Access Compliance Report

Public Rights-of-Way (Curb Ramps)

Intersection ID: 11556	Main Street: HARRILL_ST	Cross Street: PARKWOOD_AV	Location: NW
ADA ID: 6C4B6D77EFDC	Ramp Type: PerpDiag	Initial Pass/Fail: Fail	Overall Compliance: No
Severity Score: 58.75			
Codes/Mitigation Info/Possible Solution		Field Measurements/Component Compliance

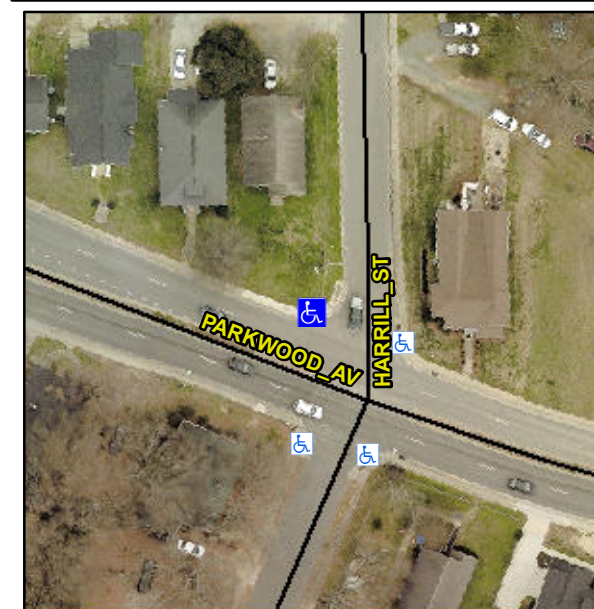
Not Found, R304.5.1, R304.2.2, R304.5.3

Compliance	Description	Data	Compliance	Description	Data
N/A	Ramp Length (in)	55.5	No	Ramp Slope (%)	13.0
No	Ramp Width (in)	38.5	No	Ramp XSlope (%)	9.3
N/A	Flare Type LT	N/A	N/A	Flare Type RT	N/A
N/A	Flare Slope LT (%)	N/A	N/A	Flare Slope RT (%)	N/A
N/A	Flare Traversable LT?	N/A	N/A	Flare Traversable RT?	N/A
N/A	Landing Length (in)	N/A	N/A	DWS Provided?	N/A
N/A	Landing Width (in)	N/A	N/A	DWS Contrast?	N/A
N/A	Landing Slope (%)	N/A	N/A	DWS Length (in)	N/A
N/A	Landing X Slope (%)	N/A	N/A	DWS Full Width?	N/A
N/A	Landing Curb? (Y/N)	N/A	N/A	DWS Offset (in)	N/A
N/A	Shared Landing?	N/A			
N/A	Gutter Ponding?	N/A	N/A	Gutter Slope (%)	N/A
N/A	Gutter Lip Ht (in)	N/A	N/A	Gutter X Slope (%)	N/A
N/A	Painted X Walk1?	No	N/A	Painted X Walk2?	No
	X Walk 1 Direction	To S		X Walk 2 Direction	To SE
N/A	X Walk 1 Width (in)	N/A	N/A	X Walk 2 Width (in)	N/A
	X Walk 1 Slope (%)	2.7		X Walk 2 Slope (%)	6.6
	X Walk 1 X Slope (%)	5.8		X Walk 2 X Slope (%)	2.0

N/A	Ramp inside XWalk1?	N/A	N/A	Ramp inside XWalk2?	N/A
	Road Slope (%)	7.7	N/A	Clear Space?	N/A
	Road X Slope (%)	1.9	N/A	Clear Space to XWalk (in)	N/A
N/A	Any Obstructions?	N/A	N/A	Storm Grate/Utility Hazard?	N/A
	Obstruction Type			Storm Grate/Utility Type	
		N/A			N/A
		Yes		Surface Condition? (G/P)	Good

Remove & Replace Curb Ramp With Two New Directional Ramps or Equivalent.
